**PROCUREMENT SERVICES
ADDENDUM**

Date of Notice:	1/22/2025
Solicitation No.:	IB-010-25
Title:	HSC Restroom Renovations
Addendum No.:	1

IB-010-25

Addendum 1

55B-FP101

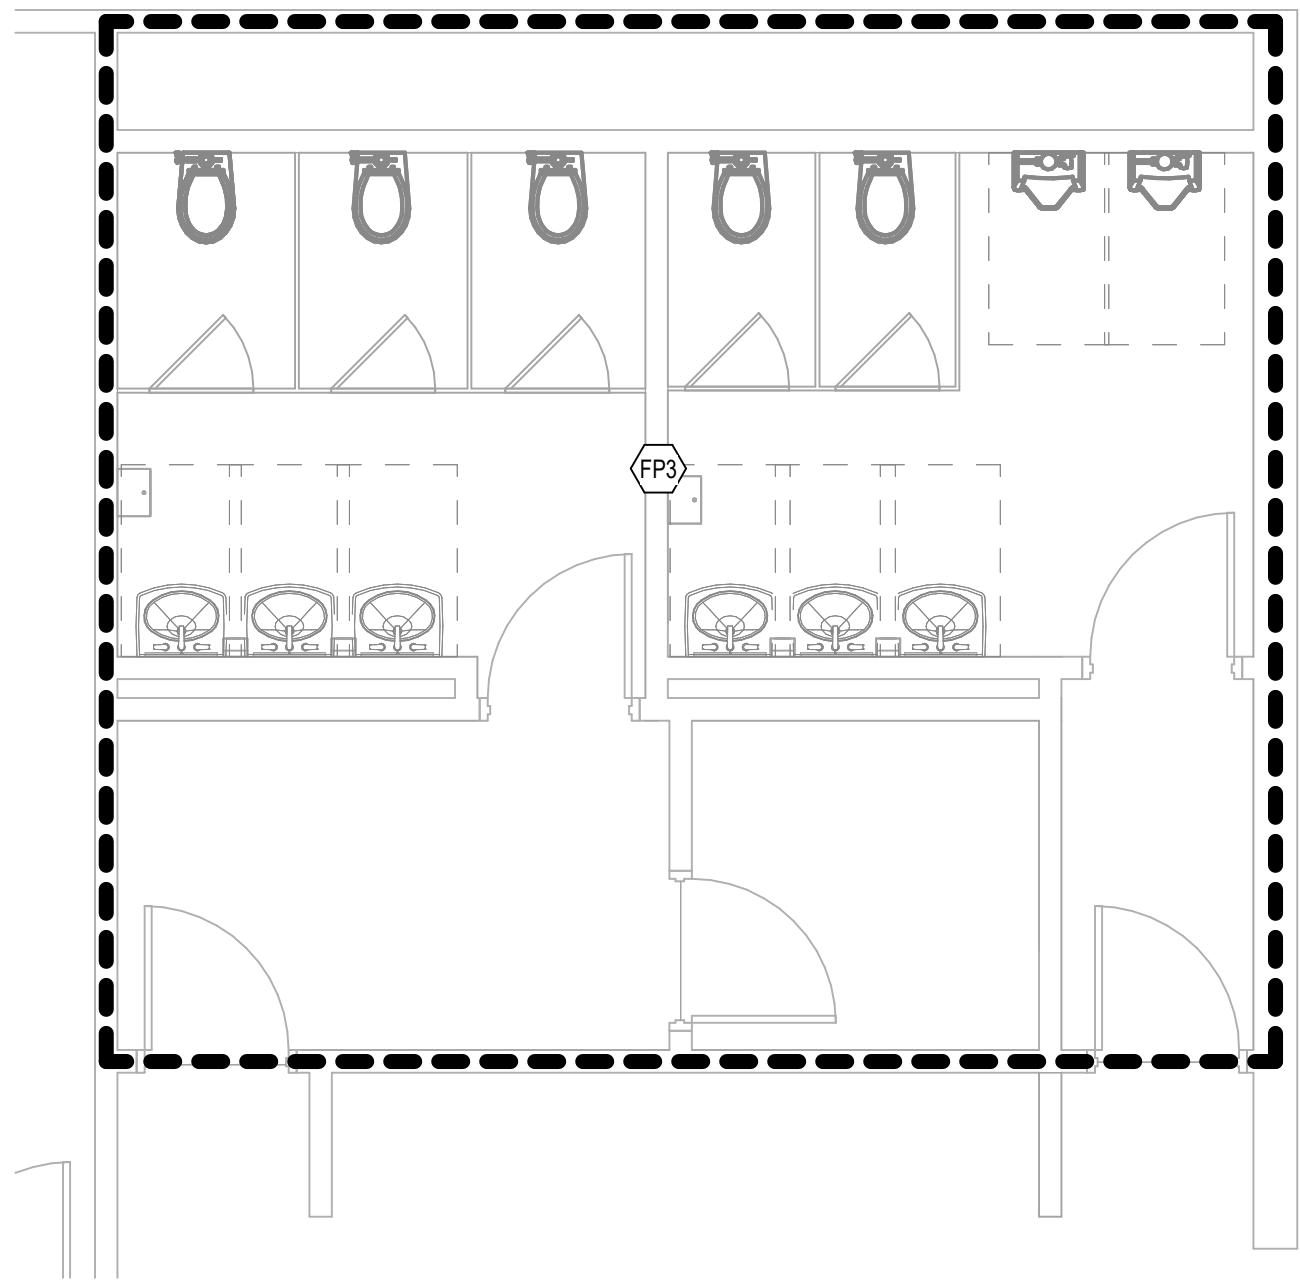
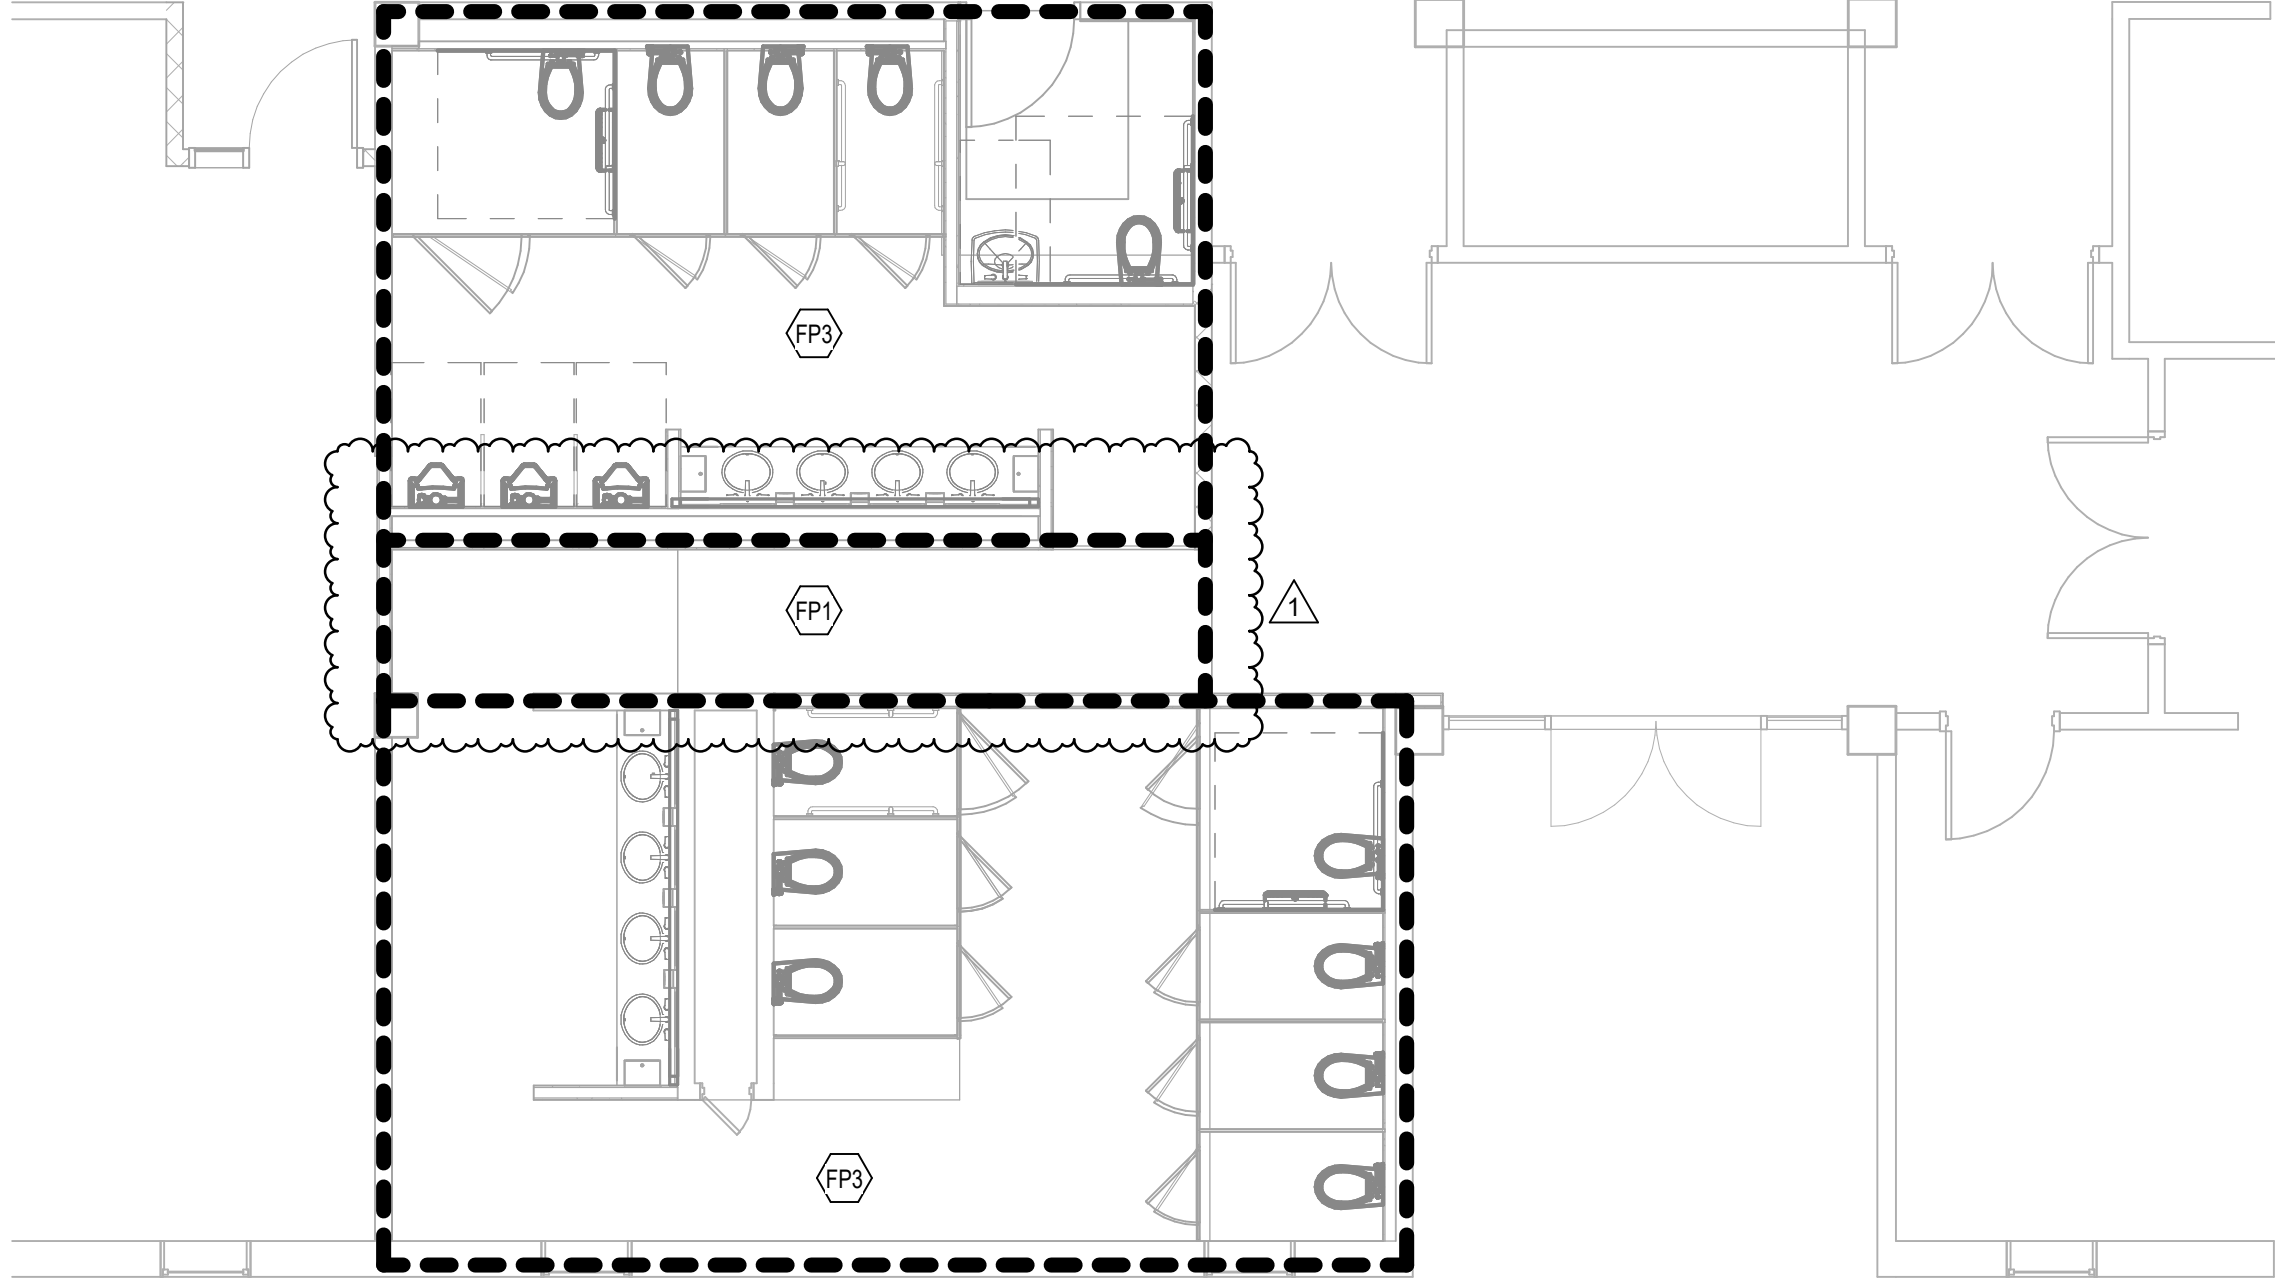
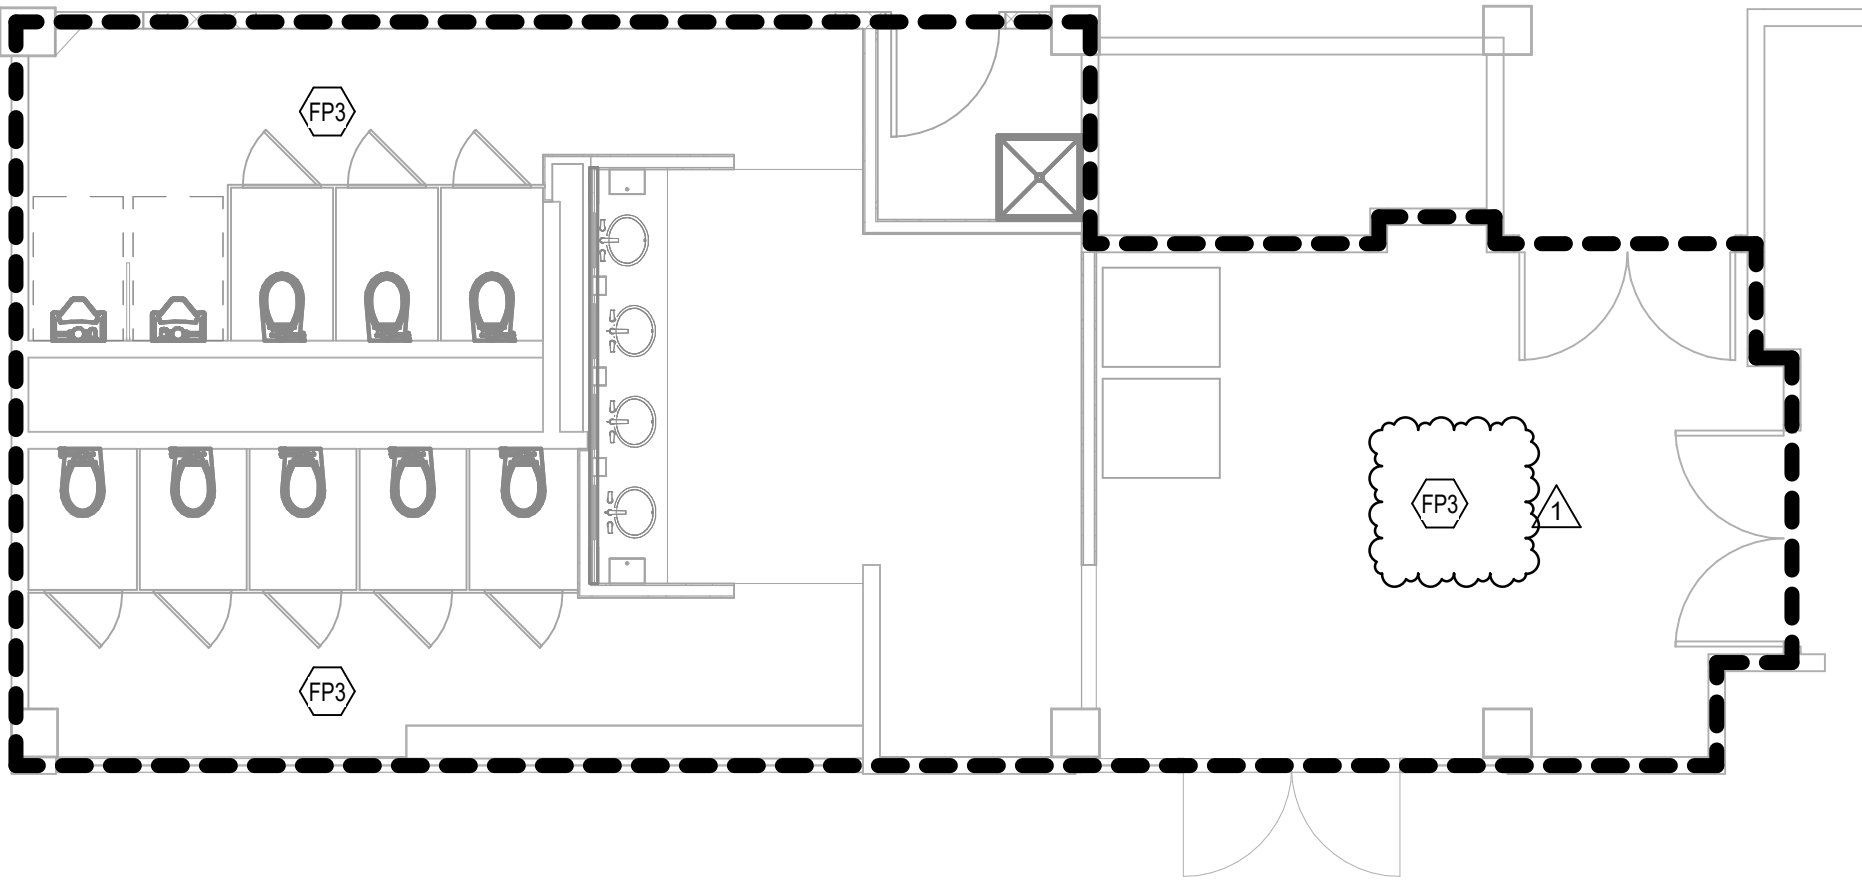
6. Is there any sprinkler scope for 55B building?

University Response: For Fire Protection scope within 55B, see **revised sheets 55BFP101** for clarification of scope.
